From: Terry Tunmore [REDACTED]
Sent: 05 April 2019 14:31
To: Anita Gardner
Cc: Debbie Tunmore
Subject: Conditions Discharge - 44 Tarrant Street, Arundel. AB/17/19 DOC

AB/17/19/DOC - 44 Tarrant Street, Arundel

Opening F2
Measures
51cms width
84cms height

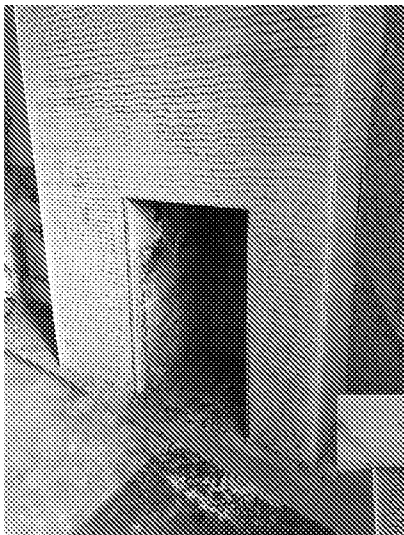
Rooms F2 and S3: the proposed design is acceptable for these rooms – will it look exactly the same as pictures in the statement, in terms of size and colour? Please confirm. We confirm the fire surrounds will look exactly the same in size and be constructed in solid timber. The colour will be to match that of the general scheme and I would have hoped not subject to approval but please advise if this is the case. [For reference surrounds duplicated below]

NOTE: Fireplaces in
F2 and S3 were
bricked up prior
